# Access Compliance Report

## Public Rights-of-Way

### (Curb Ramps)

Intersection ID: N/A	Main Street: DURANT_BV	Cross Street: N/A	Location: S
ADA ID: FDABFABD66E5	Ramp Type: PerpDiag	Initial Pass/Fail: Fail	Overall Compliance: No
			Severity Score: 46.25

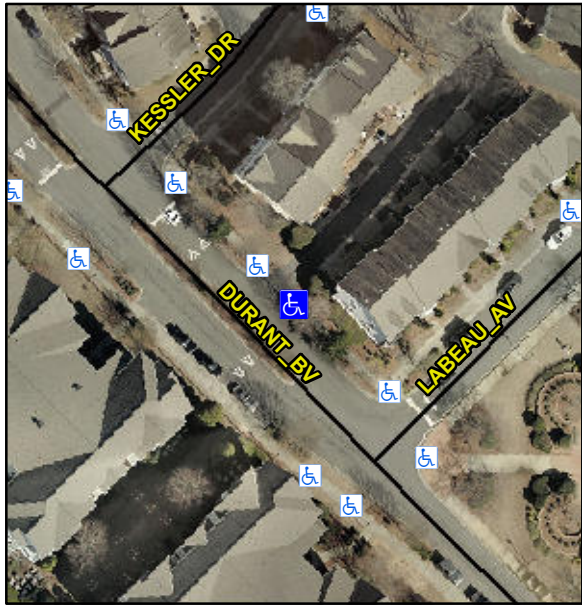
Codes/Mitigation Info/Possible Solution			Field Measurements/Component Compliance					
	Possible Solutions:		Compliance	Description	Data	Compliance	Description	Data
	Remove & Replace Curb Ramp With Two New Directional Ramps or Equivalent.		N/A	Ramp Length (in)	125.0	No	Ramp Slope (%)	11.3
			No	Ramp Width (in)	46.0	No	Ramp XSlope (%)	7.2
			N/A	Flare Type LT	N/A	N/A	Flare Type RT	N/A
			N/A	Flare Slope LT (%)	N/A	N/A	Flare Slope RT (%)	N/A
			N/A	Flare Traversable LT?	N/A	N/A	Flare Traversable RT?	N/A
			N/A	Landing Length (in)	N/A	N/A	DWS Provided?	N/A
			N/A	Landing Width (in)	N/A	N/A	DWS Contrast?	N/A
			N/A	Landing Slope (%)	N/A	N/A	DWS Length (in)	N/A
			N/A	Landing X Slope (%)	N/A	N/A	DWS Full Width?	N/A
Surveyor Notes:			N/A	Landing Curb? (Y/N)	N/A	N/A	DWS Offset (in)	N/A
PROW/ADA:			N/A	Shared Landing?	N/A			
Not Found, R304.5.1, R304.2.2, R304.5.3			N/A	Gutter Ponding?	N/A	N/A	Gutter Slope (%)	N/A

N/A	Gutter Lip Ht (in)	N/A	N/A	Gutter X Slope (%)	N/A
			N/A	Painted X Walk1?	No	N/A	Painted X Walk2?	No
				X Walk 1 Direction	To NW		X Walk 2 Direction	To W
			N/A	X Walk 1 Width (in)	N/A	N/A	X Walk 2 Width (in)	N/A
				X Walk 1 Slope (%)	1.9		X Walk 2 Slope (%)	3.6
				X Walk 1 X Slope (%)	4.2		X Walk 2 X Slope (%)	4.4
			N/A	Ramp inside XWalk1?	N/A	N/A	Ramp inside XWalk2?	N/A
				Road Slope (%)	7.1	N/A	Clear Space?	N/A
				Road X Slope (%)	0.2	N/A	Clear Space to XWalk (in)	N/A
			N/A	Any Obstructions?	N/A	N/A	Storm Grate/Utility Hazard?	N/A
				Obstruction Type			Storm Grate/Utility Type	
					N/A			N/A
						Yes	Surface Condition? (G/P)	Good
Total Cost:		\$ 3200.00						
Street 1 Name		ENTRANCE						
Stop Condition-Street 2		StopSign						
Street 2 Name		DURANT BV						
Stop Condition-Street 1		None
